VALUE ENGINEERING MOD 1 TRAINING REPORT

Turner Hill/Rockland Road Widening

Project No. STP-0006-00(891)

March 11, 2009

A-3-1

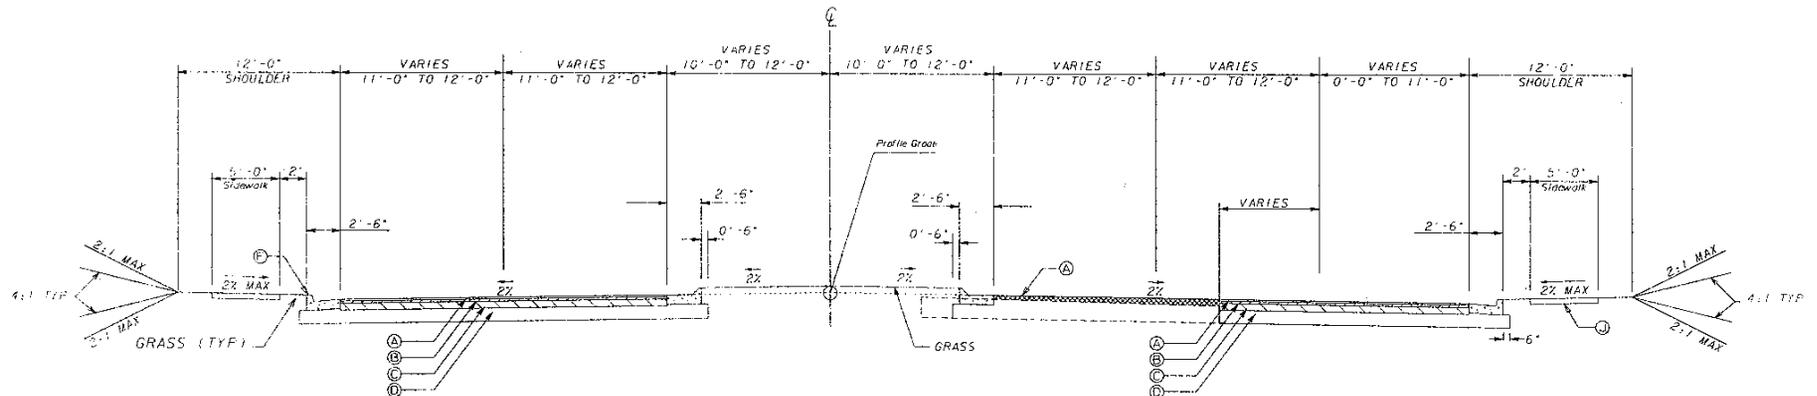
DEVELOPMENT AND RECOMMENDATION PHASE			
Project: STP-0006-00(891), P.I. No. 0006891, DeKalb County			
Idea No.: A-3	Sheet No.: 1 of 4	CREATIVE IDEA: Reduce Shoulder Width	
Comp By: CAC		Date: 2-25-09	Checked By: Date: 2-26-09
<p>Original Concept: The original typical section includes a 16' wide shoulder on the westside and a 22' wide shoulder on the east side of Turner hill Road</p> <p>Proposed Change: It is recommended that the westside shoulder width be reduced from a 16' to a 12' and the eastside shoulder width be reduced from a 22' to a 12'.</p> <p>Justification: The larger shoulder width is not a requirement but rather a preference. By decreasing the shoulder width, the cost of earthwork and r/w decreases while maintaining the basic function of the shoulder. This proposal assumes that the 10' multi-use path and lighting is eliminated or the width reduced from the project.</p>			
LIFE CYCLE COST SUMMARY	INITIAL Project Cost	FUTURE Project Cost	TOTAL Present Worth Cost

INITIAL COST: Original	\$3,885,000		
Proposed	\$2,765,000		
Savings	\$1,120,000		
FUTURE COST: Savings			
TOTAL PRESENT WORTH SAVINGS			\$1,120,000

SKETCH A-5-1

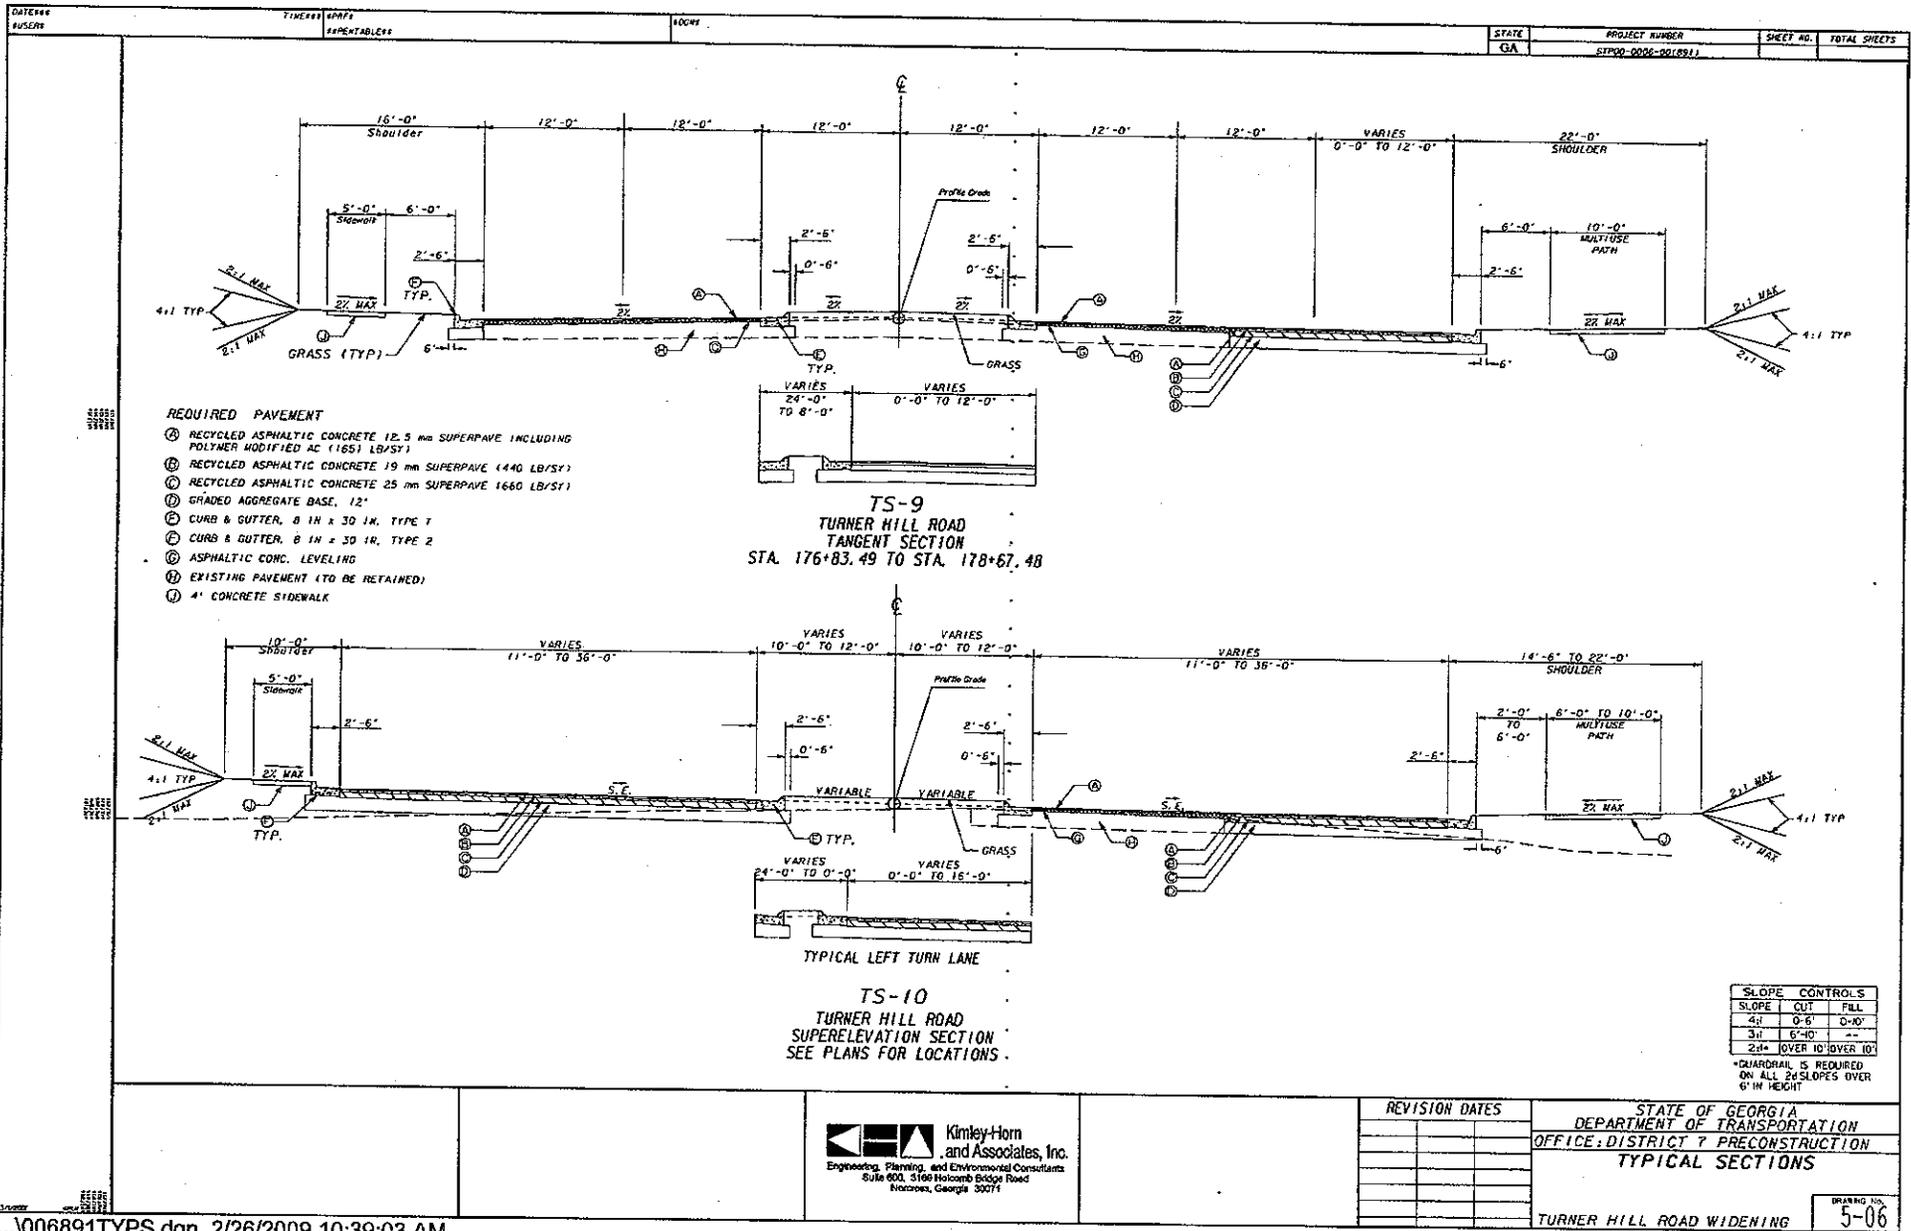
DEVELOPMENT AND RECOMMENDATION PHASE			
Project: STP-0006-00(891), P.I. No. 0006891, DeKalb County			
Idea No.: A-5	Sheet No.: 1-4	CREATIVE IDEA: Eliminate median	
Comp By: AS	Date: 2-26-09	Checked By:	Date: 2-26-09
<p>Original Concept: Original proposal has a 24-foot raised grassed median. The speed design is 35 mph. The Base 2010 ADT = 16,500; Design 2030 ADT = 23,700.</p> <p>Proposed Change: Eliminate the raised median and have a four lane section, widening at the intersections for turn lanes.</p> <p>Justification: For the base and design year ADT volumes for this roadway classification, The GDOT Design Policy Manual for arterial medians (section 6.8.2) calls for a 5-lane section. Because this project has very limited driveways, the two-way left turn lane (TWLTL) is only required as a left turn lane at the intersections (signalized and un-signalized locations). Therefore in the areas between intersections, a 4-lane undivided section significantly reduces the borrow earthwork and the right-of-way requirements while maintaining an acceptable LOS.</p>

IDEA A-5: ELIMINATE MEDIAN

LIFE CYCLE COST SUMMARY	INITIAL Project Cost	FUTURE Project Cost	TOTAL Present Worth Cost
INITIAL COST: Original	\$6,705,000		
Proposed	\$5,675,000		
Savings	\$1,030,000		
FUTURE COST: Savings			
TOTAL PRESENT WORTH SAVINGS			\$1,030,000

Idea No.: A-6 - 1
Client: Dekalb/GDOT
Sheet 2 of 6

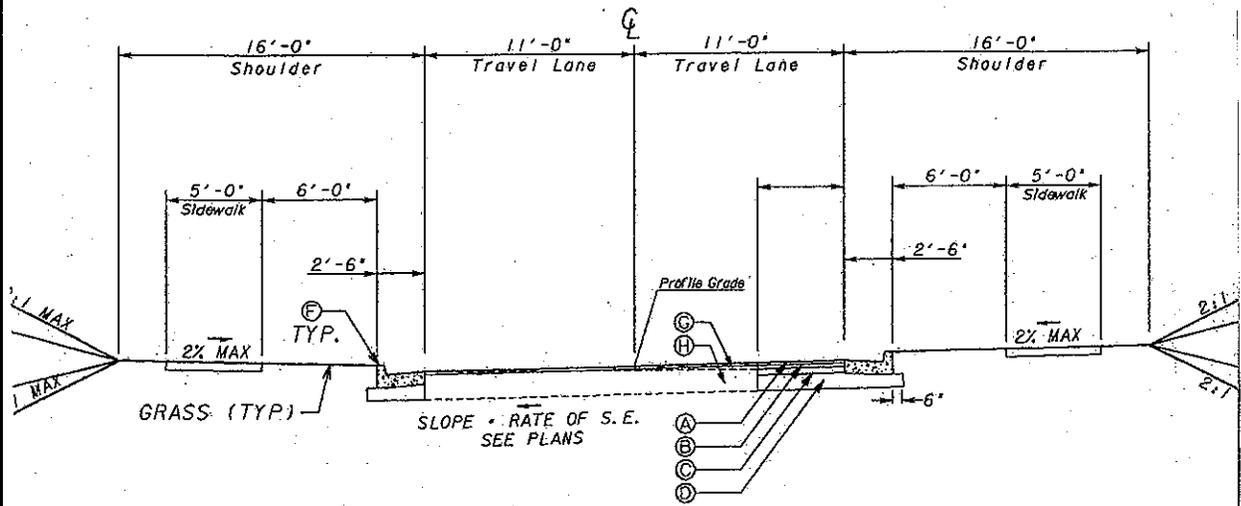
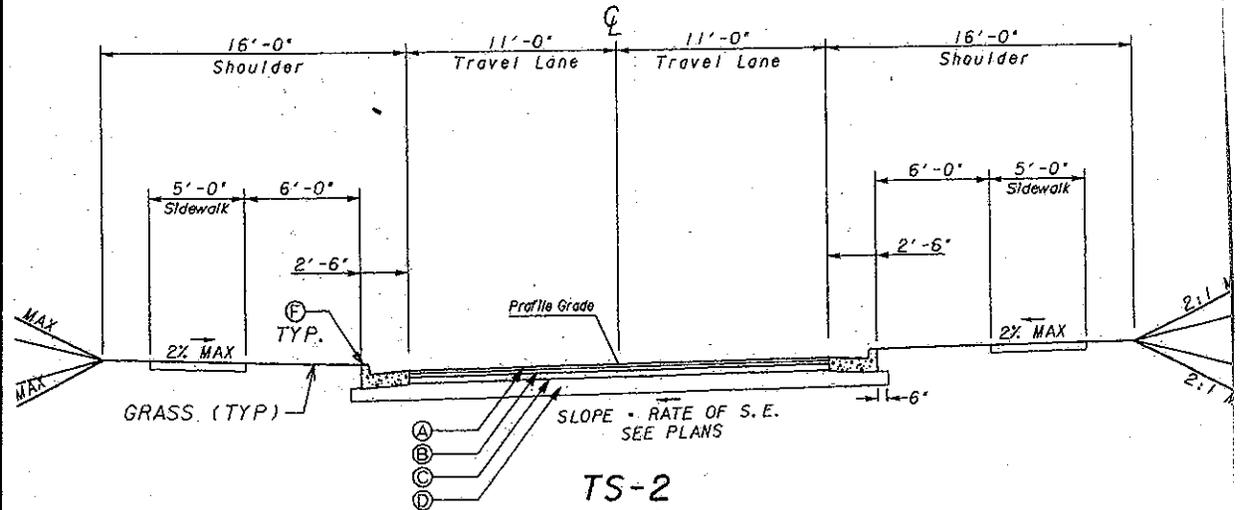
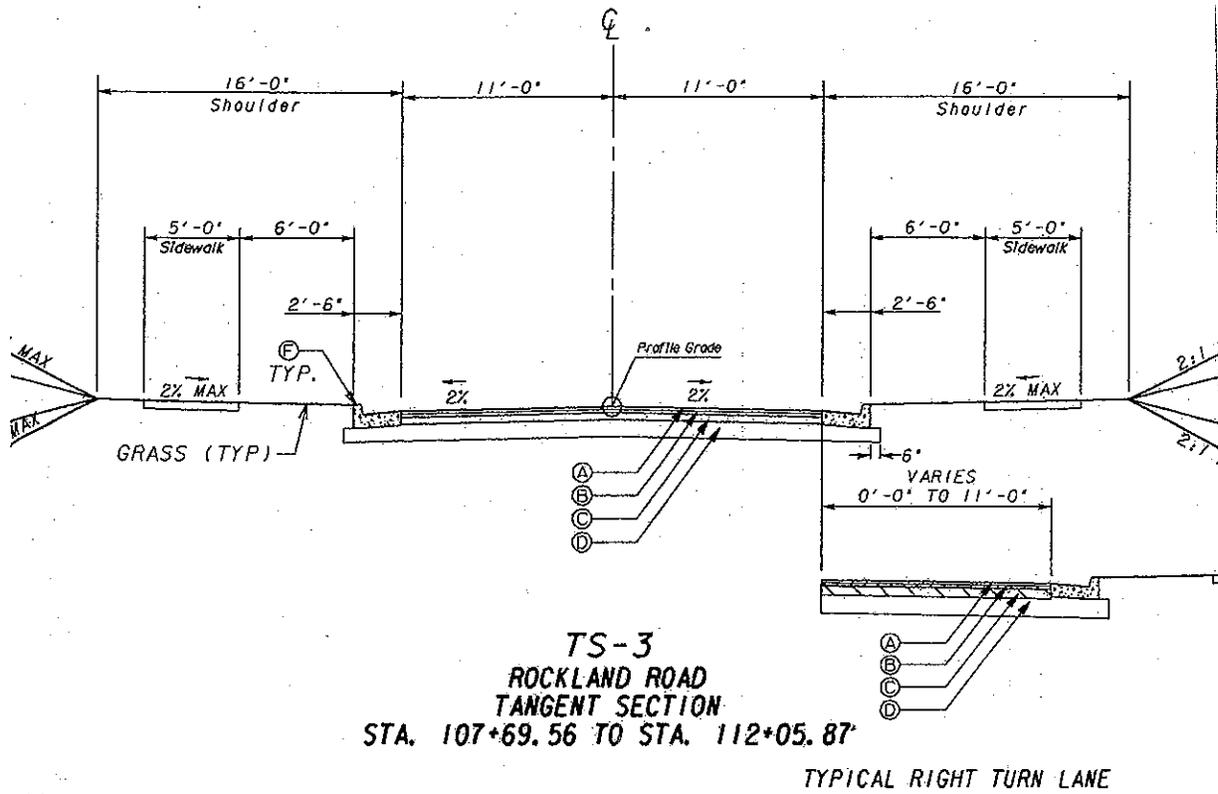
DEVELOPMENT AND RECOMMENDATION PHASE			
Project: STP-0006-00(891), P.I. No. 0006891, DeKalb County			
Idea No.: A-6	Sheet No.: 1 of 6	CREATIVE IDEA: Shorten Length of Project	
Comp By: NA		Date: 2-25-09	Checked By: Date: 2-26-09
<p>Original Concept: The project proposes to begin approximately 1500' west of McDaniel Mill Road at STA 104+25.</p> <p>Proposed Change: It is recommended to begin project approximately 700' west of McDaniel Mill Road at STA 112+00, thus reducing the project length by 775'</p> <p>Justification: Begin shortening the project length, you can reduce the amount of paving & earthwork. The traffic analysis shows that the logical termini is McDaniel Mill Road. The traffic drops along Rockland Road from 18,700 vpd to 11,800 vpd from the west side of McDaniel Mill Road to the east side of McDaniel Mill Road. Also, the project ties into the existing grade at STA 112+00. A horizontal curve can be added to tie into the existing alignment. Although earthwork calculations were not performed, there will be some added savings with this elimination of the pavement section.</p>

LIFE CYCLE COST SUMMARY	INITIAL Project Cost	FUTURE Project Cost	TOTAL Present Worth Cost
INITIAL COST: Original	\$ 4,808,000		
Proposed	\$ 4,619,000		
Savings	\$ 189,000		
FUTURE COST: Savings			\$ 189,000
TOTAL PRESENT WORTH SAVINGS			\$189,000

B-1-1

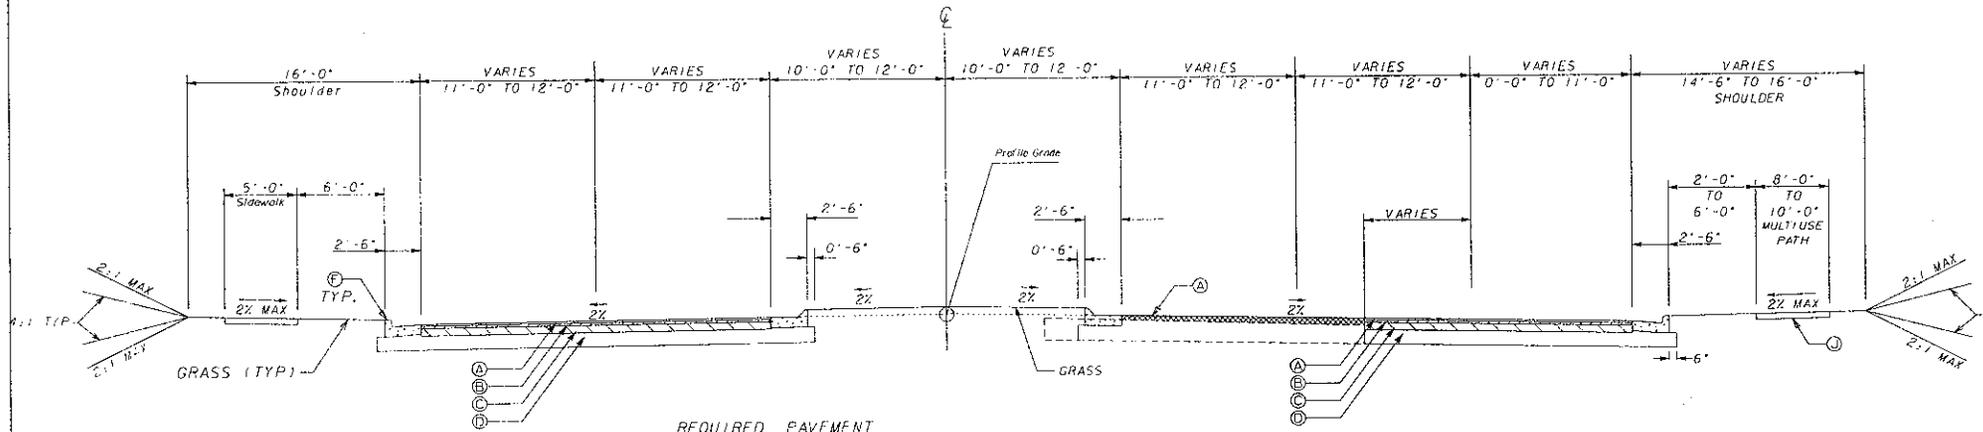
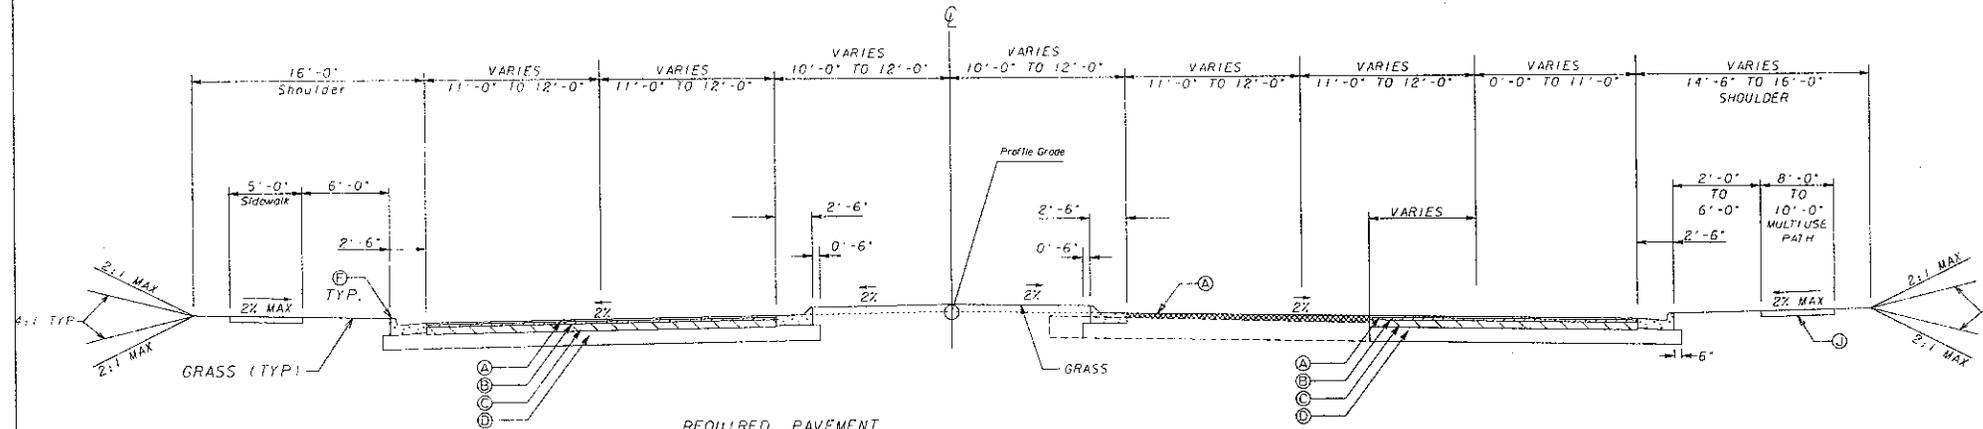
DEVELOPMENT AND RECOMMENDATION PHASE			
Project: STP-0006-00(891), P.I. No. 0006891, DeKalb County			
Idea No.: B-1	Sheet No.: 1 of 4	CREATIVE IDEA: Minimize Pavement Structure	
Comp By: CAC	Date: 2-25-09	Checked By:	Date: 2-26-09
<p>Original Concept: The original pavement design utilized 11 ½” of Recycled Asphalt on top of a 12” layer of Graded Aggregate Base.</p> <p>Proposed Change: It is recommended to utilize 9 ½” of Recycled Asphalt on top of 10” of Graded Aggregate Base.</p> <p>Justification: The original pavement structure is overdesigned by 10.2%. According to the Pavement Design Manual, “...Projects with urban shoulders, curb and gutter, shall be designed between 0 to 5% under designed.” The proposed pavement design has a structural number of 5.08 and the roadway has a required structural number of 5.44. Therefore the proposed pavement structure would be 6.7% under designed. However, the proposed design is well above the minimum for State Route pavement structures. In addition, this is an off system roadway with a low percentage of trucks (6%) thus making it a good candidate for a reduced design structure. Reducing the pavement structure would provide cost savings while providing an adequate design.</p> <p>Note: Polymer Modified Asphalt was used on both the Surface Course and the intermediate course and on this route it is not needed and it being eliminated will provide additional savings</p>

LIFE CYCLE COST SUMMARY	INITIAL Project Cost	FUTURE Project Cost	TOTAL Present Worth Cost
INITIAL COST: Original	\$3,432,000		
Proposed	\$2,620,000		
Savings	\$812,000		
FUTURE COST: Savings			\$812,000
TOTAL PRESENT WORTH SAVINGS			\$ 812,000

I-1-1

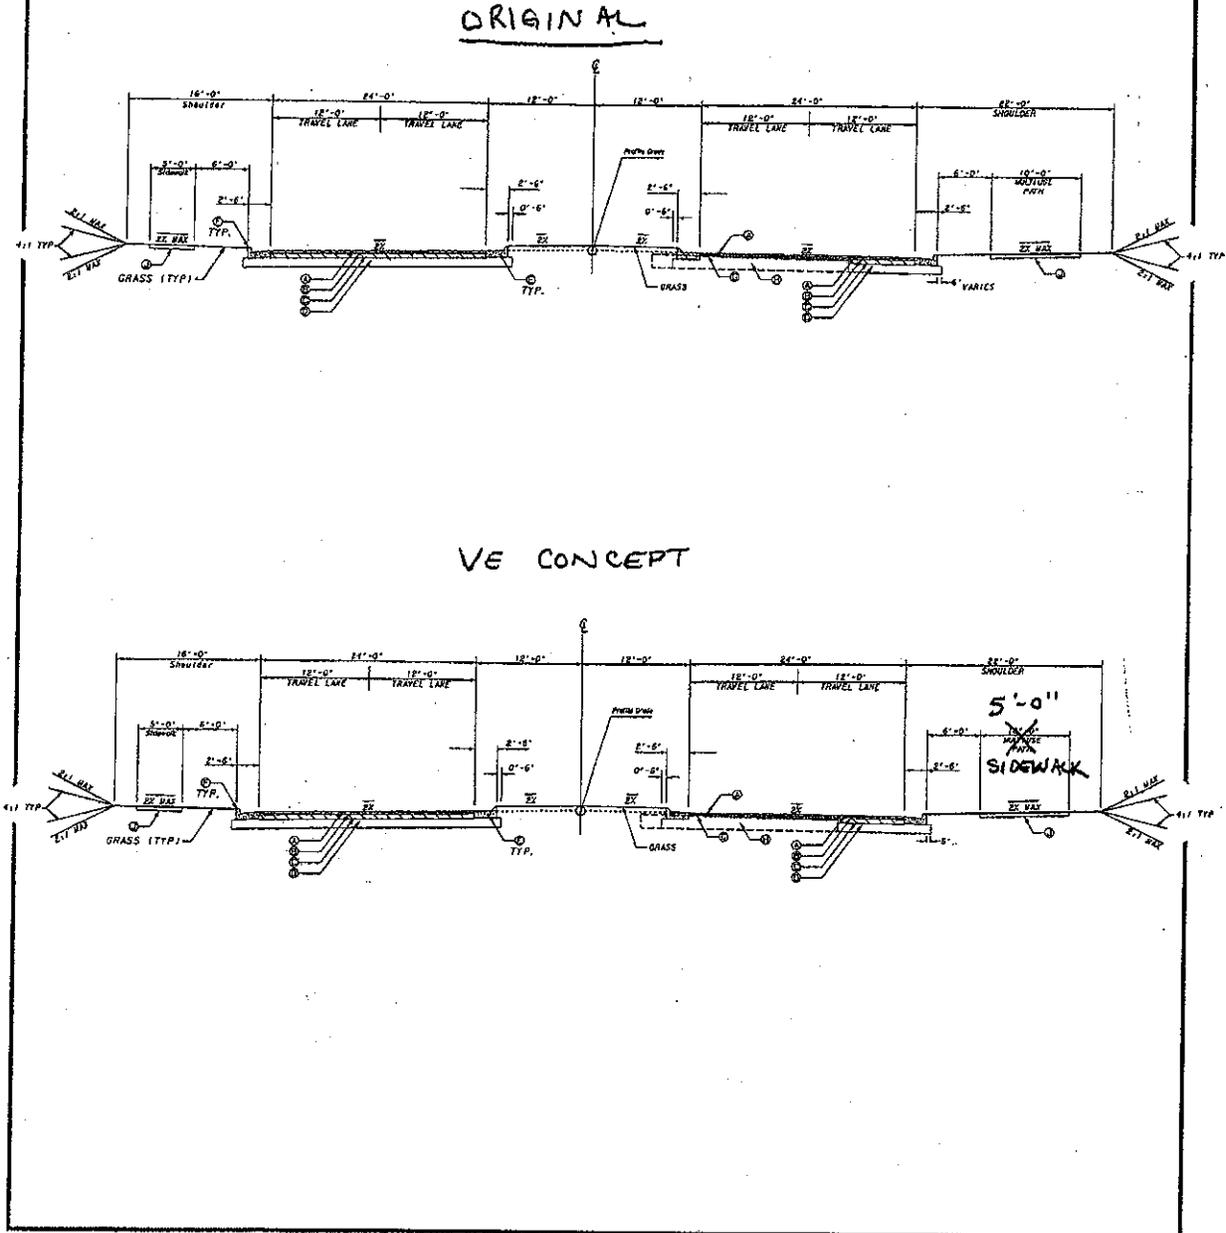
DEVELOPMENT AND RECOMMENDATION PHASE			
Project: STP-0006-00(891); PI 0006891; Turner Hill/Rockdale Road Widening			
Idea No.: I-1	Sheet No.: 1 of 4	CREATIVE IDEA: Eliminate Multiuse Path	
Comp By: J.L.F.	Date: 2-26-09	Checked By:	Date: 2-26-09
<u>Original Concept:</u>			
The proposed project calls for a 10' concrete multiuse path starting at Station 20+90 RT on McDaniel Mill Road. The path continues west toward Turner Hill Road turns north and continued north on Turner Hill Road ending at Station 178+32.			
<u>Proposed Change:</u>			
It is recommended that the 10' wide concrete multiuse path width be minimized to a 5' concrete sidewalk.			
<u>Justification:</u>			
The 10' multiuse path on this project is proposed to connect to a future multiuse path on McDaniel Mill Road. The construction of a 5' concrete sidewalk would still allow direct access to the future McDaniel Mill Road multiuse path and still provide pedestrian walkway along the project corridor. This change would reduce the construction cost of the pedestrian walkway. In addition, the path is not part of the basic Need and Purpose for the project.

LIFE CYCLE COST SUMMARY	INITIAL Project Cost	FUTURE Project Cost	TOTAL Present Worth Cost
<u>INITIAL COST:</u> Original	\$393,000		
Proposed	\$276,000		
Savings	\$117,000		
<u>FUTURE COST:</u> Savings			
TOTAL PRESENT WORTH SAVINGS			\$117,000
